# Access Compliance Report

## Public Rights-of-Way

Intersection ID: 9954	Main Street: PARKWAY_AV	Cross Street: N/A	Location:	S
ADA ID: FB6636B71B7	Ramp Type: Directional1	Initial Pass/Fail: Fail	Overall Compliance: No	Severity Score: 35

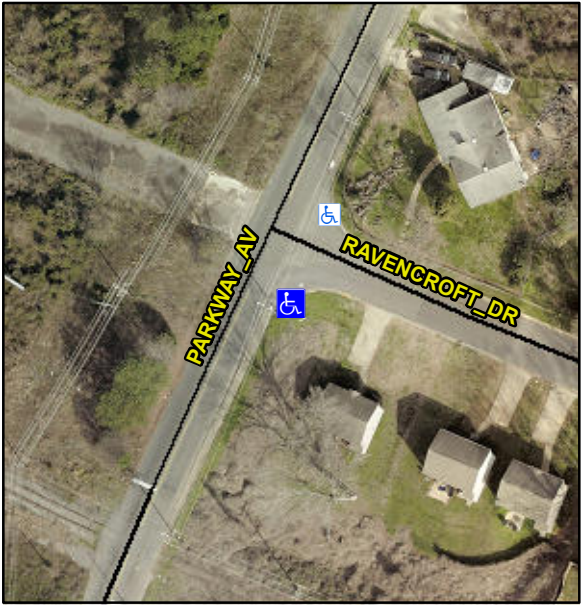
Codes/Mitigation Info/Possible Solution			Field Measurements/Component Compliance			
	Possible Solutions:		<b>Compliance</b>	<b>Description</b>	<b>Data</b>	
	Remove & Replace Entire Ramp.		N/A	Ramp Length (in)	118.0	N/A
			No	Ramp Width (in)	38.0	N/A
			No	Ramp Slope (%)	17.1	N/A
			No	Ramp XSlope (%)	2.4	N/A
			N/A	Flare Type LT	N/A	N/A
			N/A	Flare Slope LT (%)	N/A	N/A
			N/A	Flare Traversable LT?	N/A	N/A
			N/A	Flare Type RT	N/A	N/A
			N/A	Flare Slope RT (%)	N/A	N/A
<p>Surveyor Notes:</p> <p>N/A</p>			N/A	Flare Traversable RT?	N/A	N/A
			N/A	Landing Length (in)	0.0	N/A
			N/A	Landing Width (in)	0.0	N/A
			N/A	Landing Slope (%)	0.0	N/A
			N/A	Landing X Slope (%)	0.0	N/A
			N/A	Landing Curb? (Y/N)	N/A	N/A
			N/A	Shared Landing?	N/A	N/A
			N/A	Gutter Ponding?	0.0	N/A
			N/A	Gutter Lip Ht (in)	0.0	N/A
			N/A	Painted X Walk1?	No	N/A
<p>PROW/ADA:</p> <p>R304.5.1, R304.2.2, R304.5.3</p>			N/A	X Walk 1 Direction	To N	N/A

N/A	X Walk 1 Width (in)	N/A	N/A
			N/A	X Walk 1 Slope (%)	5.7	N/A
			N/A	X Walk 1 X Slope (%)	0.0	N/A
			N/A	Ramp inside XWalk1?	N/A	N/A
			N/A	Any Obstructions?	N/A	N/A
				Obstruction Type		N/A
			Yes	Surface Condition? (G/P)		Good
			N/A	Curb Slope (%)		N/A
Total Cost:		\$ 1600.00
